STAFF REPORT

APPLICATION CP 86-C-121-3

HUNTER MILL DISTRICT

YMCA OF METROPOLITAN WASHINGTON
COMMUNITY RECREATIONAL FACILITY

CONCEPT PLAN

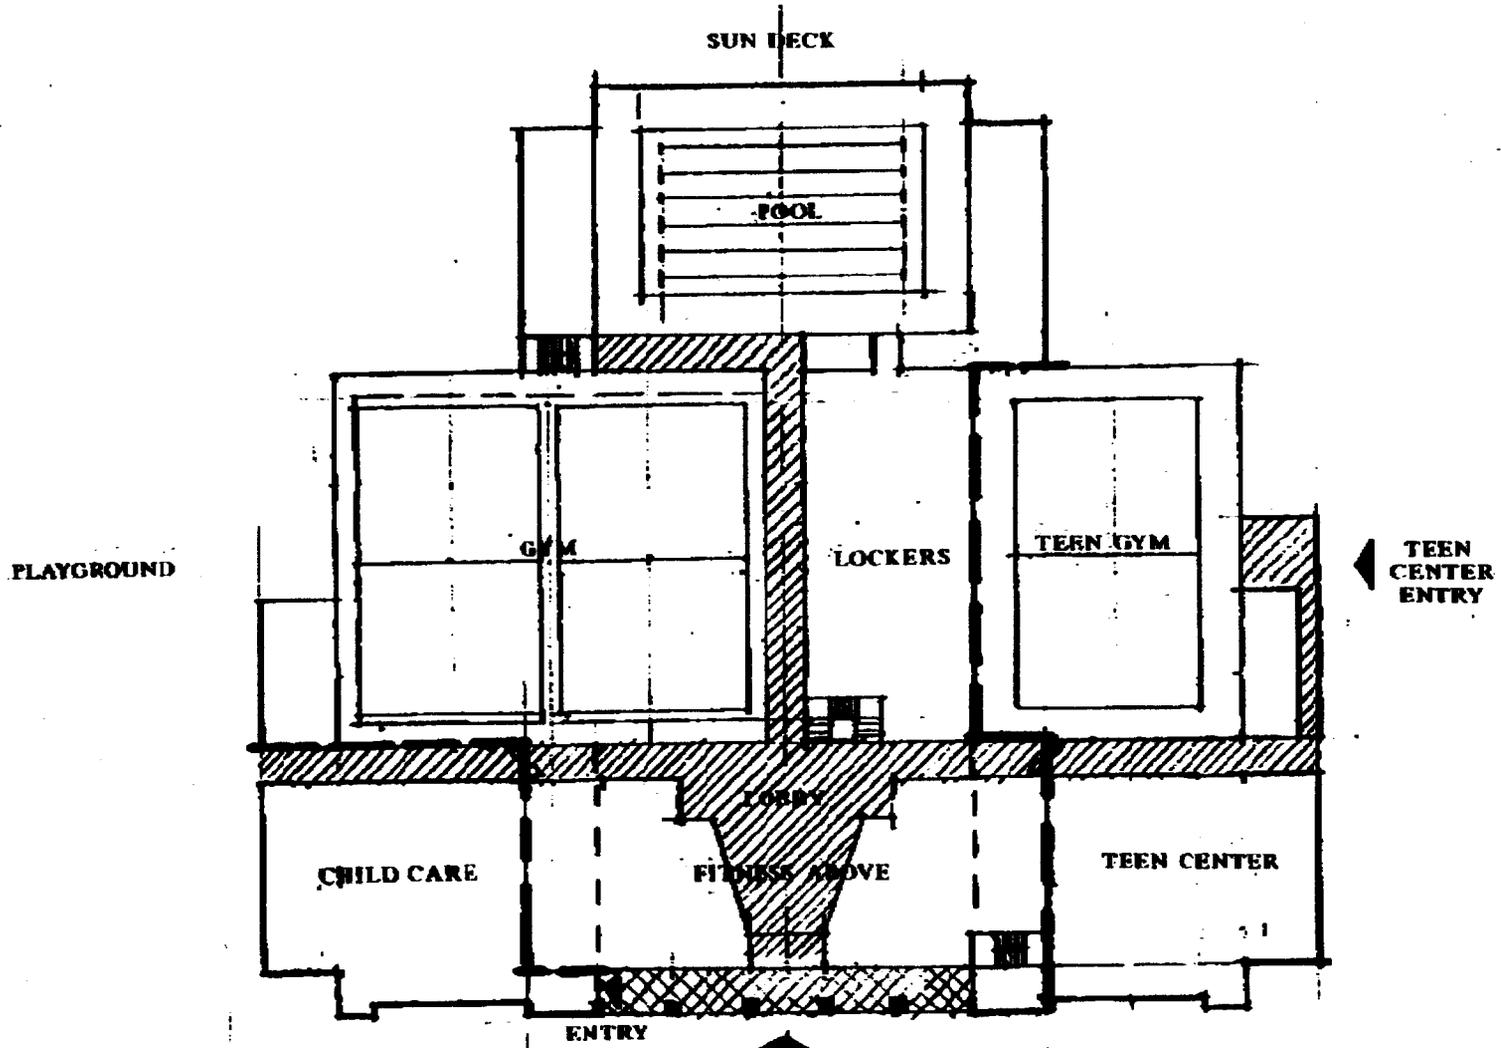
The conceptual plan displays "approximate limits of construction" that will result in avoidance of direct impacts to the wetlands from clearing and grading (with the exception of a sanitary sewer line crossing and a trail crossing) and will result in the provision of a significant buffer area within a largely cleared area to the north of the stream. The conceptual plan also displays a buffer area within the wooded area to the south of the stream that is variable in width and narrower than the buffer area being provided to the north. The buffer area to the south of the stream would vary from roughly 10 feet near the northern portion of the proposed stormwater management facility to over 40 feet in several places. It should be noted that this buffer area is generally wider than that which was shown on a previously submitted conceptual plan for the site.

In order to further improve the aesthetic value of the wetlands area, the applicant should minimize encroachments into the area and restore the area inside the limits of clearing and grading north of the stream to a more natural. The Urban Forestry Branch of DEM should be consulted for guidance regarding restoration of this area. Natural restoration, rather than plantings, may be appropriate for this area. The Conceptual Plan notes that the wetlands area shall remain in a natural

In order to reduce exterior noise to 65 dBA Ldn or less within the proposed outdoor play area, the fence along the southern (and along the southern portion of the western) boundary of the play area should be designed to provide noise mitigation benefits. The fence in this area should be of a height sufficient to break all lines of sight between traffic along Sunset Hills Road and children who will be using the play area. The fence should be architecturally solid from the ground up and should contain no gaps or openings. The applicant may pursue other methods of mitigating highway noise if it can be demonstrated, through an independent noise study for review and approval by DEM, that these methods will be effective in reducing exterior noise levels to 65 dBA Ldn or less and interior noise levels to 45 dBA Ldn or less. A note has been included on the conceptual plan to provide a six (6) foot high solid fence with no gaps or openings as suggested by staff in order to mitigate exterior noise impacts to the outdoor play area of the child care center.

Stormwater Management/Best Management Practices. The conceptual plan displays the location of a proposed stormwater management/best management practice facility. The applicant has indicated that this facility will be designed to accommodate stormwater runoff from the subject property as well as from undeveloped parcels upstream of the property. At the time of site plan review, the applicant will be required to demonstrate to DEM's satisfaction that stormwater management and BMP requirements have been addressed.

The CP shows sidewalks and trails along the Sunset Hills Road frontage of the site, through the parking areas, connecting to the undeveloped parcel to the east, crossing the stream, and connecting to the regional trail system of the W&OD trail. The CP also notes that the pedestrian system will be finalized as to exact location and materials at the time of final site plan review.

The CP depicts a densely planted landscaping strip with a minimum width of 10 feet along the Sunset Hill Road frontage of the site. The proposed landscaping within this area will consist of a mixture of evergreen trees and large deciduous trees. Existing and supplemental vegetation will be used along the Sunset Hills Road frontage of the site to screen the proposed stormwater management pond from view. Supplemental landscaping is also shown within the parking lot area.

FRONT ELEVATION

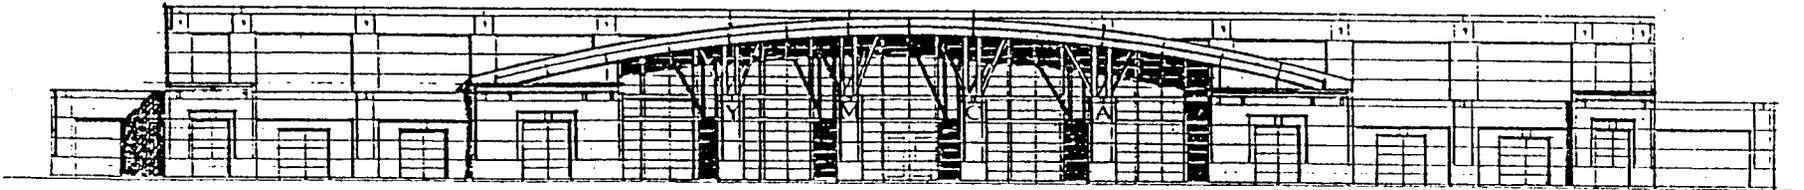
Sheet #3 of the CP depicts the front elevation of the proposed structure which is noted to be limited to a maximum height of 45 feet and limited to a maximum gross floor area of 66,000 square feet. The notes also state that the proposed architectural designs will be subject to final approval of the Reston Town Center Design Review Board.

- The east elevation will be very important due to the alternative access drive at this location and should have as high a degree of articulation and detailing as the south elevation. Perhaps the design concept of the shallow vault can be incorporated on the east elevation. The use of brick and E.I.F.S. is approved.
- A 6' width concrete sidewalk or 8' wide asphalt trail should be provided along Sunset Hills Road. Please coordinate the specific material and location with the adjacent development on Block 2.
- A landscape plan will be required, including screening along Sunset Hills Road and the adjacent property.
- Upcoming submissions need to include the other elevations, colors, materials, signage, lighting, etc.
